TRANS/WP.29/GRSP/2005/4
7 March 2005

PROPOSAL FOR DRAFT CORRIGENDUM TO THE 06 SERIES OF AMENDMENTS TO
REGULATION No. 14
(Safety-belts anchorages)

Transmitted by the expert from the United States of America

Figure 6: ISOFIX Top tether anchorage location, ISOFIX zone – Side view

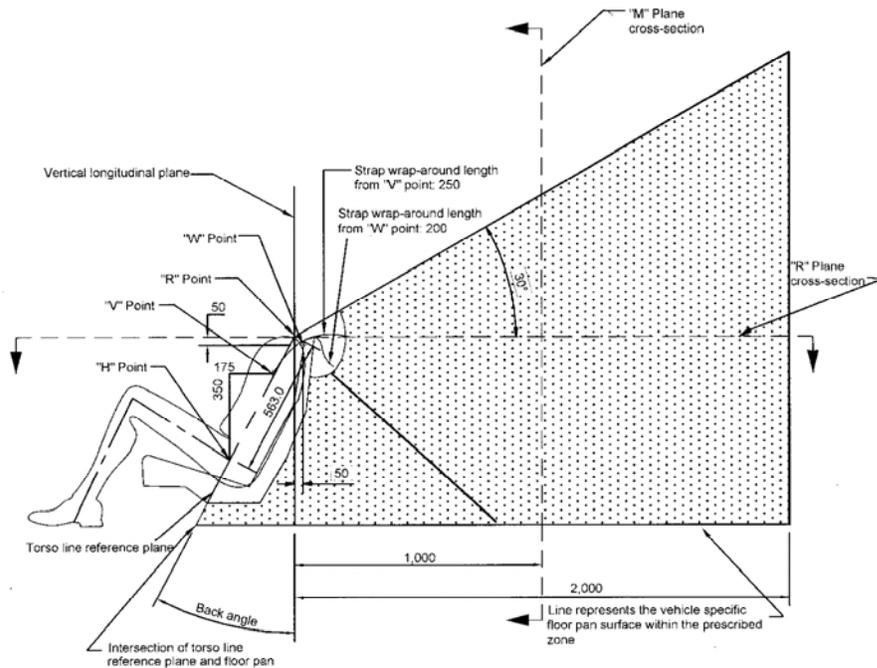
Annex 9, Figure 6

For the existing figure substitute

Figure 7: ISOFIX Top tether anchorage location, ISOFIX zone
Enlarged view of wrap-around area

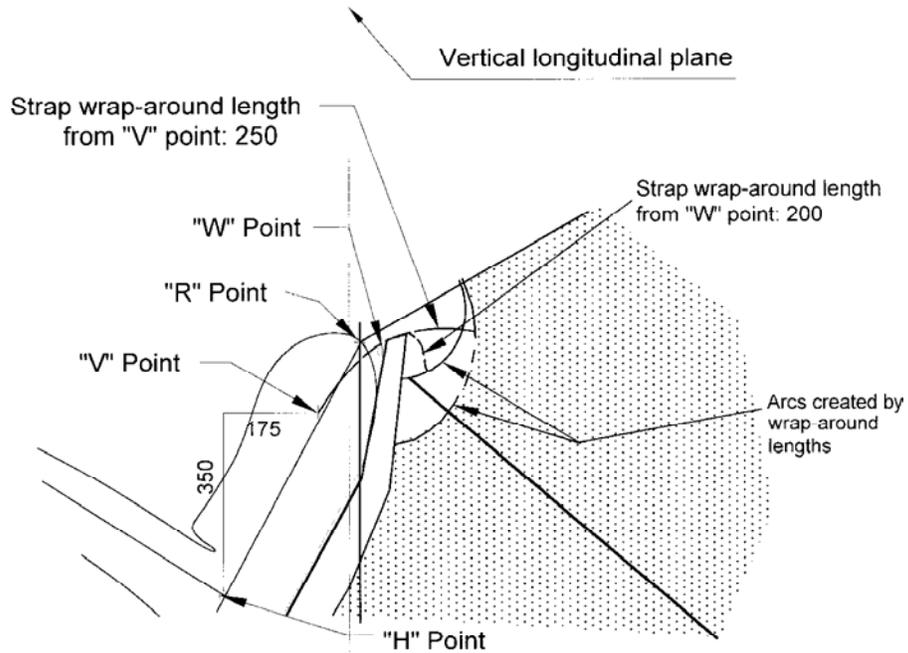
Figure 7

For the existing figure substitute
